**HOFFMAN-MADISON WATERFRONT
7/15/2011 RESPONSES TO:**

**ANC 6D Resolution in Support of
Hoffman Madison-Marquette Southwest Waterfront First Stage PUD
Case No. 11-03**

PARCEL SECTION THROUGH 10&11

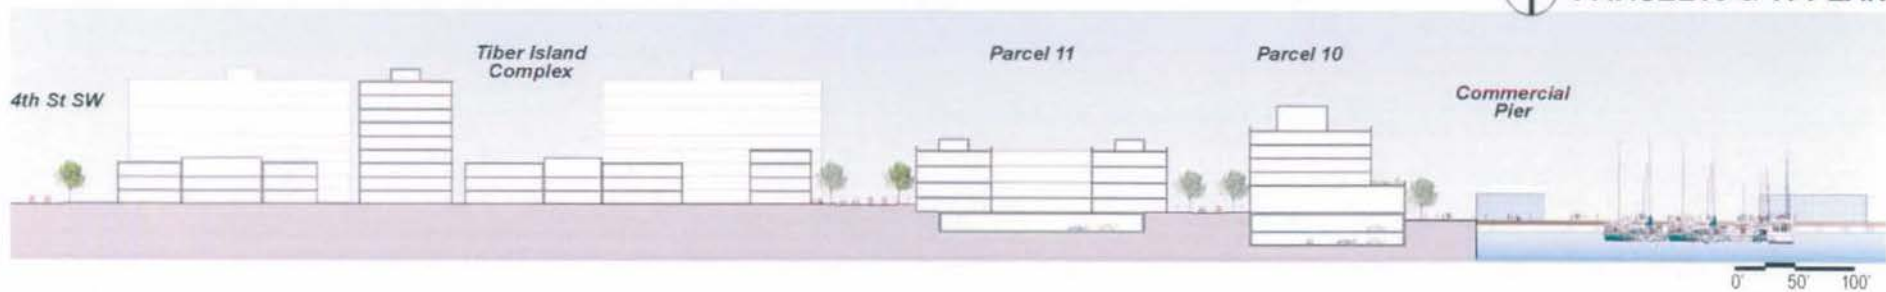
Parcel 11 - The redevelopment of Parcel 11 into a dense residential development is a concern. While ANC 6D is prepared to accept this change, the resultant development must not be inconsistent with the existing residential fabric. Preservation of the height limitations within the R-3 district is necessary to ensure Parcel 11 is sensitively integrated within the existing successful, well-knit fabric of low-rise townhouses that defer to the public space by exhibiting generous setbacks. In particular, setbacks on residential (South) side of M Street from Sixth Street to Second Street, SW share generous setbacks that the design on Parcel 11 does not appear to embrace. Further, the lack of setbacks within the design on Maine Avenue provides a stark counterpoint to the significant lush setbacks provided by the lawns on the Maine Avenue side of The Meade Center.

M Street Landing – ANC 6D believes that Parcel 9 and 10 need to be brought down to 90 and 45 feet high, respectively, and that Parcel 11 be set back within the M Street corridor. This crucial area anchoring the waterfront development needs to more successfully exhibit sensitivity to the existing residential neighborhood. As proposed, these buildings create a jarring transition. The St. Augustine Episcopal Church bulges

out on Parcel 11 eliminating views on the southern half of the grand boulevard leading to the Southwest Waterfront from points east. This violation of the L'Enfant Plan is inconsistent with existing and proposed buildings lining M Street and should be brought in line to successfully create a sense of arrival at the Waterfront – as promised in plans for the Waterfront going back more than eight years -- among other urban design objectives. ANC 6D needs to be assured that the height of the buildings on Parcel 11 will be no higher than 45 feet so that it fits within its waterside and low-rise residential context. The height of Parcel 9 should be tapered so that it's in line with buildings on the opposing side of the Landing and provides a transition to the taller buildings to the north. Most importantly, topping out Parcel 9 at 90 feet would ensure it doesn't diminish the landmark Meade Center for American Theater.

HMW Response: *HMW recognizes the concern and has recently improved its plans to demonstrate that the proposed use and structure is compatible with the existing neighborhood. It should also be understood that the height limitations for a church in existing R-3 is sixty feet, and for other structures it is 40 feet. The effective height of the existing residential along 6th Street SW, the area of most impact, is +/- 40' with the grade change which makes the proposed residential development compatible with the existing Tiber 4 story townhomes and not significantly different than the existing zoning height requirements. The existing setback at Tiber Island from the curbline is approximately 22' to the garden wall and approximately another 20' to the building face of the four story townhomes for a total of 42'. The proposed development will allow a 12' setback from the curbline to the landscape fence (3' tall) and a total of approximately 30' to the building face of the proposed residential structure. The building separation between the face of closest Tiber townhomes and the face of the new residential building will be approximately 100'. The section along 6th Street SW looking south will be similar on the Tiber / HMW sides of the street making the development compatible with the existing fabric. (See Exhibit A). The proposed Church setback along Maine Avenue/M Street is similar to all existing structures along the south side of the street and will not significantly inhibit views along the view corridor and out to the water (See Exhibit B).*

HMW Response: *The proposed Church setback along Maine Avenue/M Street is similar to all existing structures along the south side of the street and will not significantly inhibit views along the view corridor and out to the water (See Exhibit B). The height of Parcel 11 will be no higher than 45' for the residential and 49' for the church as indicated in the Updated PUD Submission Page 5.7. Parcel 9 and 10 have been carefully shaped and positioned in close coordination with the Arena stage and their architect Bing Thom. Arena Stage is our closest and most impacted neighbor (Tiber Island residences are approx. 550 feet away). The primary concern was not building heights but setbacks to allow for a grand Maine Avenue terminus at M Street landing and a framed view of the theater looking back. The setbacks were achieved by diminishing the building floor plate significantly and reducing the square footage of program on Parcel 9 and 10. The approved outcome, which was created in working closely with Bing Thom and Arena Stage, was very specific and is now reflected in our PUD application. This design won the support of Arena Stage. Additional reduction of program through height or additional setbacks is not acceptable. The Arena Stage letter of support and supporting diagrams is attached as Exhibit C and the Illustrative plan before the negotiations is attached as Exhibit D.*
